22 October 2012

Reference: Stackpole Creek Bridge, Saco

FIG. A: HYBRID SCHEME LONGITUDINAL SECTION
 $\frac{1}{8}'' = 1'-0''$

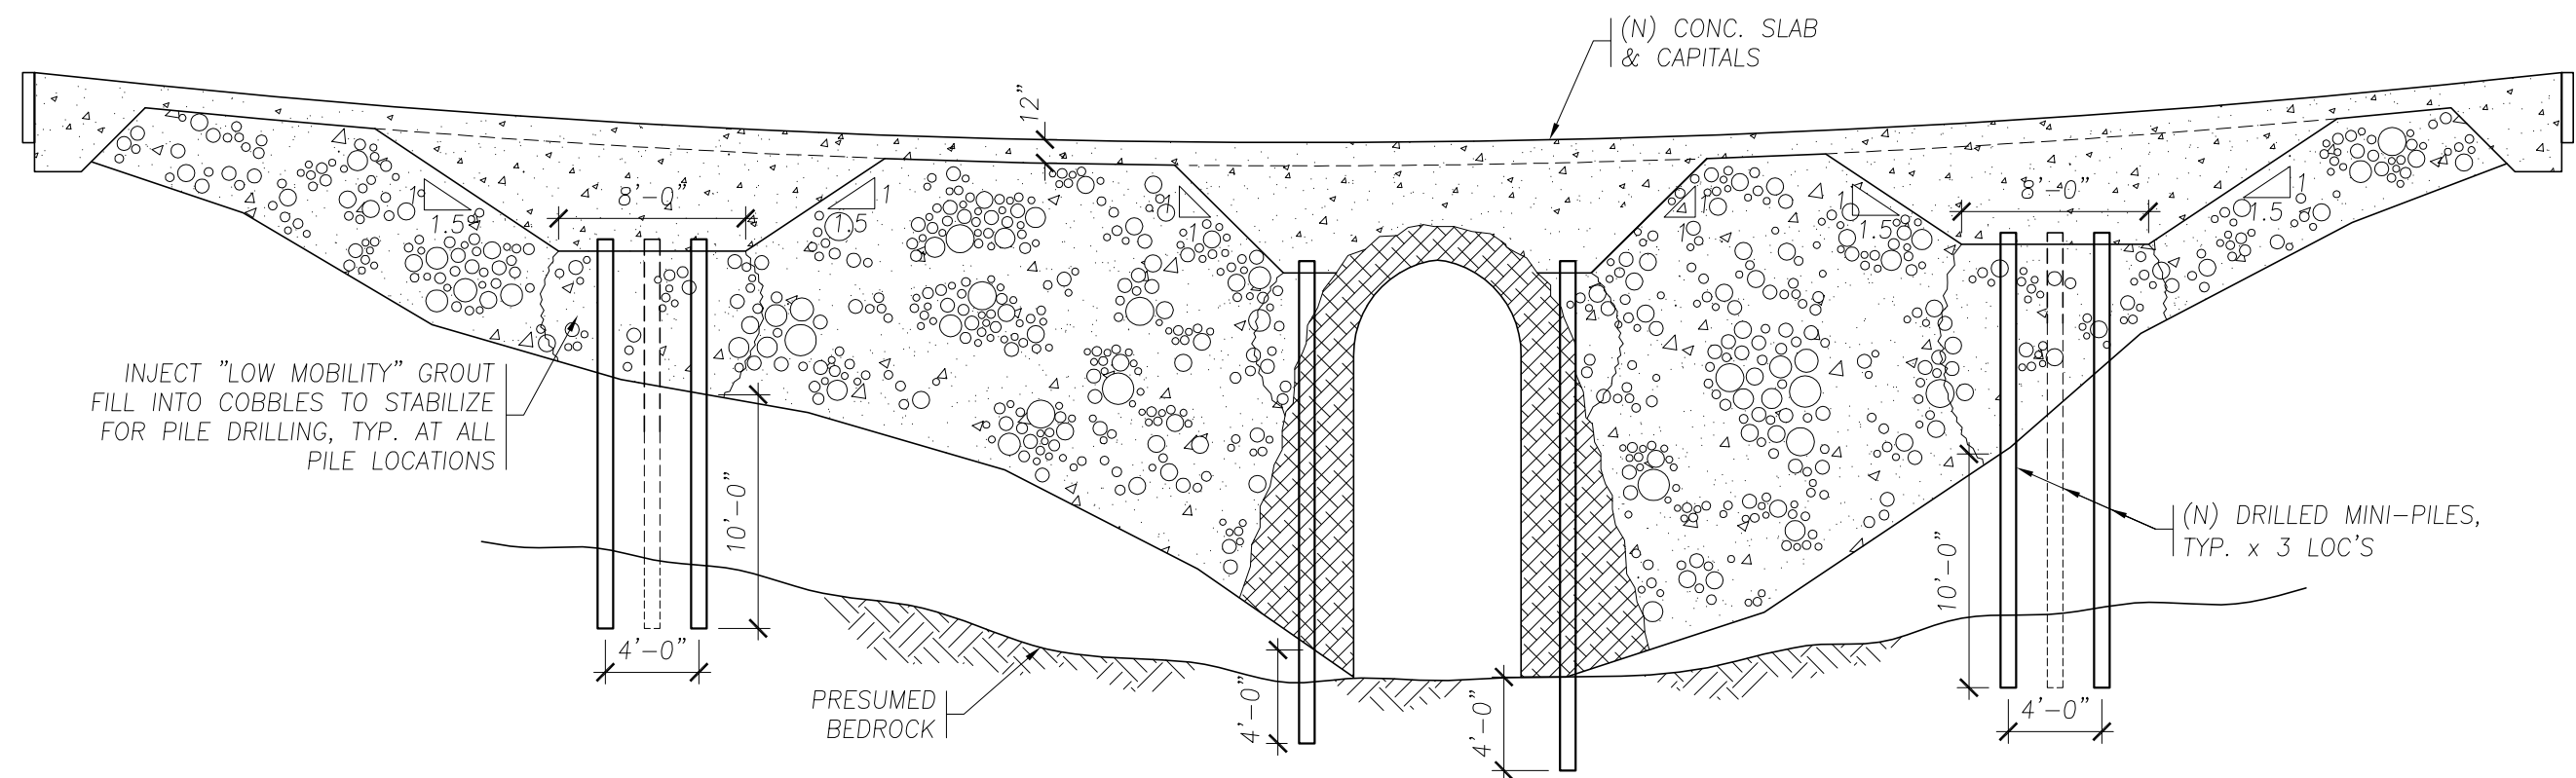
This would be constructed as follows (please refer to Fig. A and B which graphically represent this scheme):

1. The present asphalt road surface would be removed along with the side rails and top course of stones from the side walls, which would be tagged, numbered, and stored. This lowering creates a plane to receive the concrete slab.

2. The top surface would be excavated an additional 2- to 3-feet down to the top of the cobble fill along the upstream side of the bridge, exposing the back surfaces of the sidewalls, which would be chinked and pointed. Stainless steel pins would be set into the backs of some of the stones. This depression becomes a lowered concrete haunch to help buttress the top of the upstream wall.

7. Cone shaped depressions would be made in the cobble fill at about mid-distance on the embankment structures to each side of the arch span. These would later be filled with concrete to act as flared capitals or pile caps to support the roadway slab.

9. Similar depressions would be created at the end of the span, but to a lower depth.
10. A total of 20 drilled mini piles would be placed within the excavated roadway. These would be of approximately 8" diameter and would pass through the stabilized cobbles and any underlying soil and down to bedrock. Two piles would support each of the abutments, five piles would support each of the intermediate capitals (four vertical, one battered), and three would pass through each of the headwalls below the arch.

FIG. B: HYBRID SCHEME TRANSVERSE SECTIONS

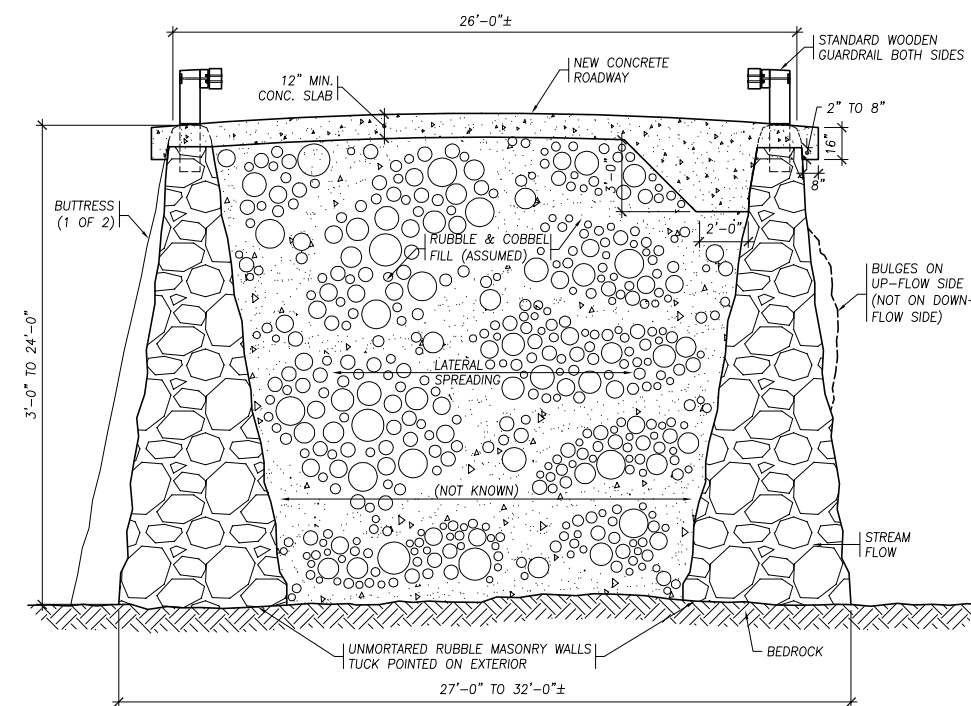
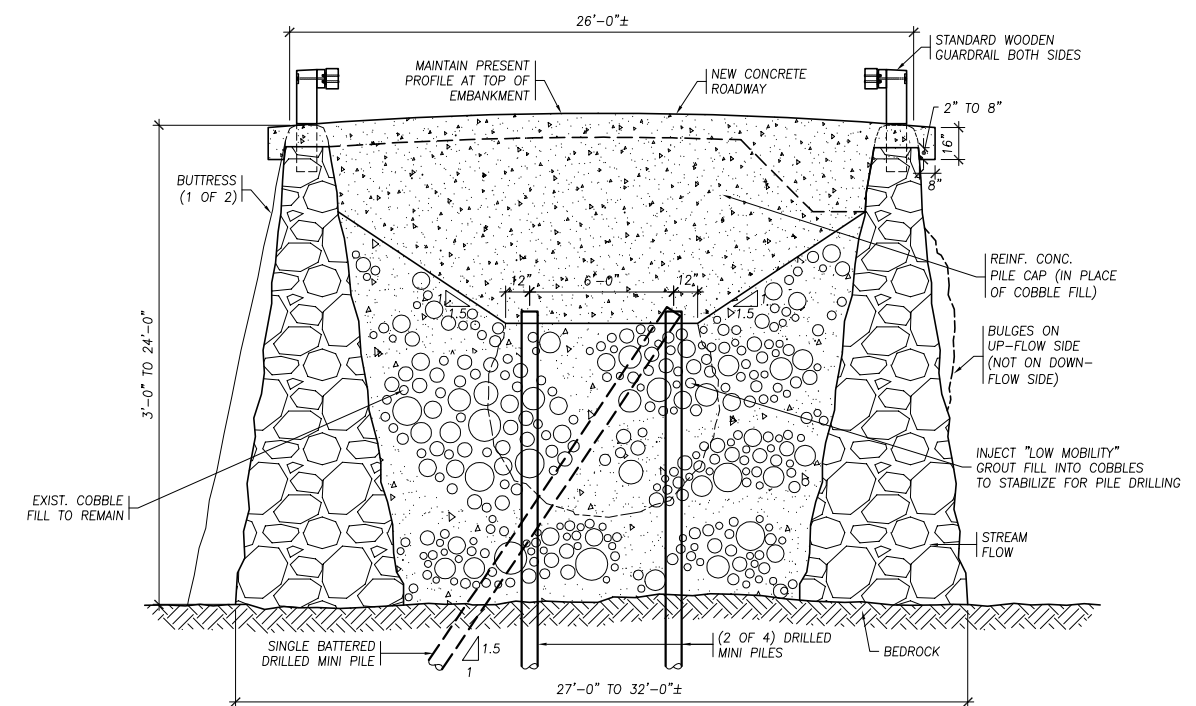
6. The cobble fill would be excavated down to expose the top of the arch span and the fill on each side would be solidified with a low motility grout in order to stabilize it for drilling. A series of 2" to 3" diameter holes would be drilled through the grouted fill and into the stone headwalls, into which would be installed Cintec sock anchors that would extend from the sidewalls in a fan like pattern, up into the excavation.

11. All of the excavated depressions, along with the buttress at the back of the north wall, would receive reinforcing "cages" and concrete to create effective pile caps on which the concrete road span could be placed. The depression over the arch span would be additionally reinforced to stop its transverse spreading.

12. A 10" to 12" structural reinforced concrete slab and wearing surface would then be placed over the capitals, north side buttress, and the tops of the stone sidewalls and extended out by 4" to 6" to create a proper "drip". Expansion joints would be incorporated over the intermediate capitals, and drained from below, and the slab surface would be given a gentle crown, for drainage off to the sides.
